**From:** "Browne, Andrea" <ABrowne@ecommunity.com>  
**To:** "Toye Simmons" <TLS@nrc.gov>  
**Date:** 5/24/05 3:21PM  
**Subject:** RE: Amendment request to delete 6.I., 6.J., and 6.L.of yourlicense

From: Toye Simmons [mailto:TLS@nrc.gov]  
Sent: Tuesday, May 24, 2005 9:42 AM  
To: Browne, Andrea  
Subject: Amendment request to delete 6.I., 6.J., and 6.L.of yourlicense

TIHH - hot lab  
for IUB sources

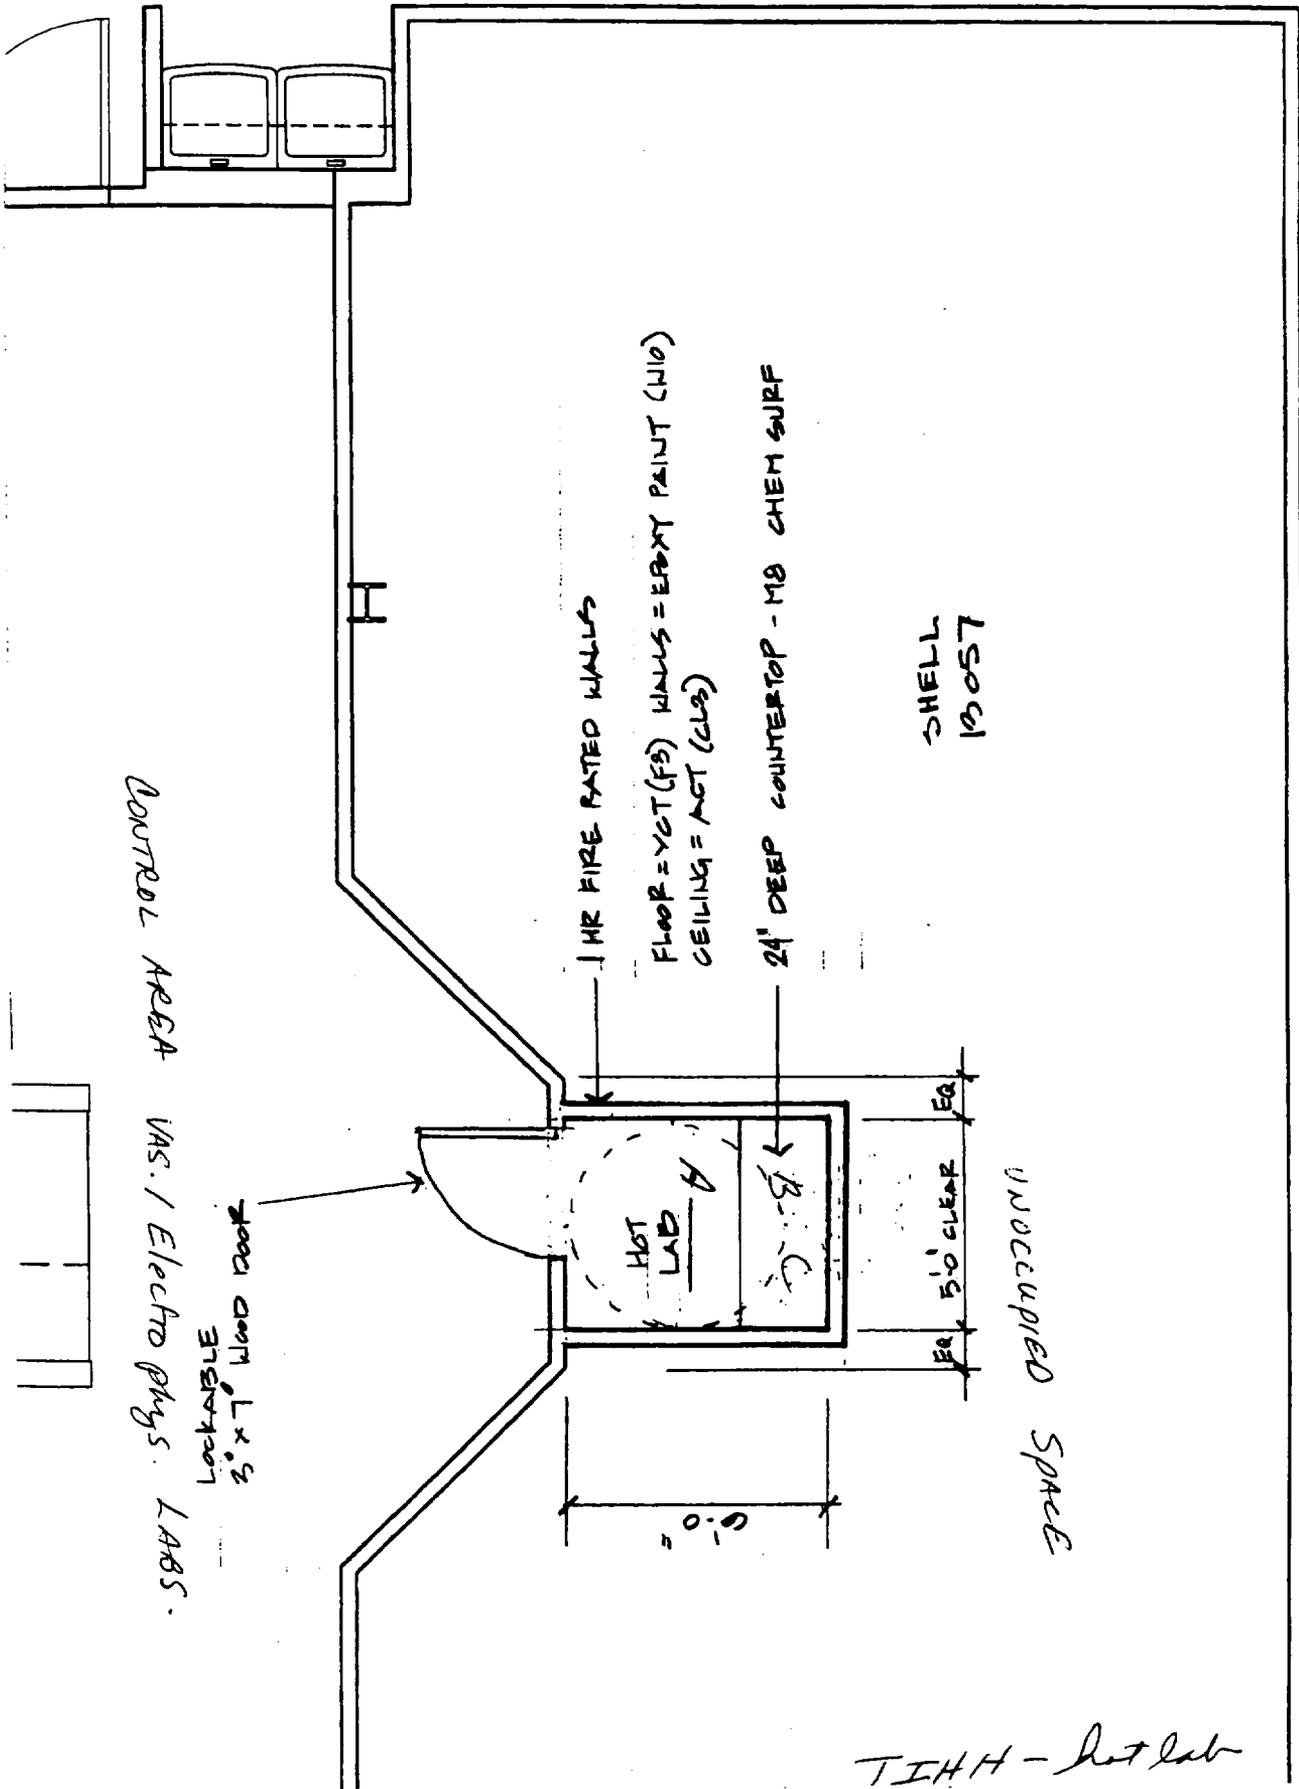
(1) Please provide disposal information for the Ir-194 and Sr-90 sources as well as for the Cordis and Novoste units, (2) Please provide a proper diagram of the facility showing the areas covered by the close-out survey, and (3) provide a close-out survey of The Indiana Heart Hospital (include diagram of use area) and confirm that all radioactive material has been removed.

1. The Ir-192 sources were returned to Cordis. No Novoste units were ever possessed.
2. A pdf file is attached with two drawings. The first is a blueprint of the area encompassing the hot lab. The second is a scaled drawing of the hot lab with letter keys indicating sites for the wipe survey.
3. The key has been transferred to a document with the data previously submitted indicating the results of the area and wipe survey.
4. Per the memo from Eric Slessinger submitted with the initial request (4/1/05) I am verifying that all radioactive material has been removed.
